RE: Indian Point Unit No. 2  
Docket No. 50-247

Your letter of October 14, 1975 requested information regarding the reactor vessel support system for Indian Point Unit No. 2. Attached are Con Edison's answers to Questions 1 and 2 forwarded by your Mechanical Engineering Branch.

MECHANICAL ENGINEERING BRANCH  
REQUEST FOR ADDITIONAL INFORMATION

IPP - MAXIMUM FORCES ACTING ON A REACTOR VESSEL SUPPORT

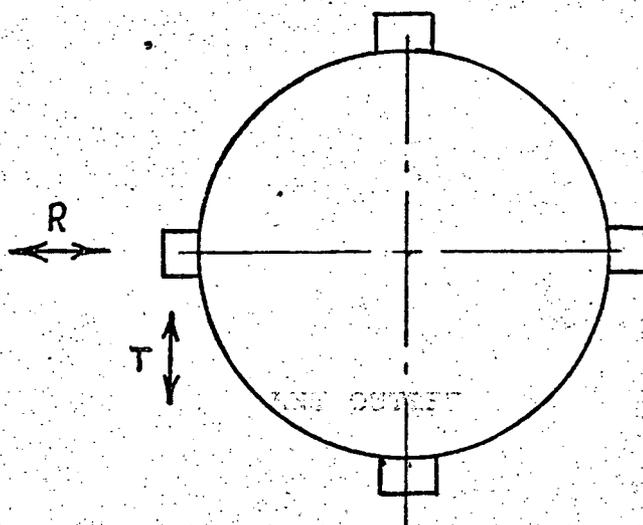
Table 1 shows the maximum loads and combined loads derived from the application of this criteria to the reactor vessel supports. These loads are

applied in the analysis to each individual support. Since the applied lateral loads on the reactor vessel are resisted by two support shoes, the total lateral load applied to the reactor vessel is twice that applied to each shoe. The highest lateral load the reactor vessel will see given the above described design basis is 2,218 kips. The steam generator supports and the reactor coolant pump supports attached to the unbroken loops also resist the applied lateral loads. This effect which was conservatively not included, is significant as it will reduce the loads transferred to the vessel support, since the total loads would be redistributed to all the supports.

A	B	C	D	$\Sigma$		
	REACTOR VESSEL WEIGHT & PIPING REACTIONS	PIPE BREAK CASE II	PIPE BREAK CASE III	EARTHQUAKE Z & VERTICAL DIRECTION	A+B	A+C	A+D
P (LB)	934,000	---	525,000	395,000	934,000	1,459,000	1,329,000
R (LB)	322,000	---	---	---	322,000	322,000	322,000
T (LB)	140,000	866,000	473,000	969,000	1,006,000	613,000	1,109,000
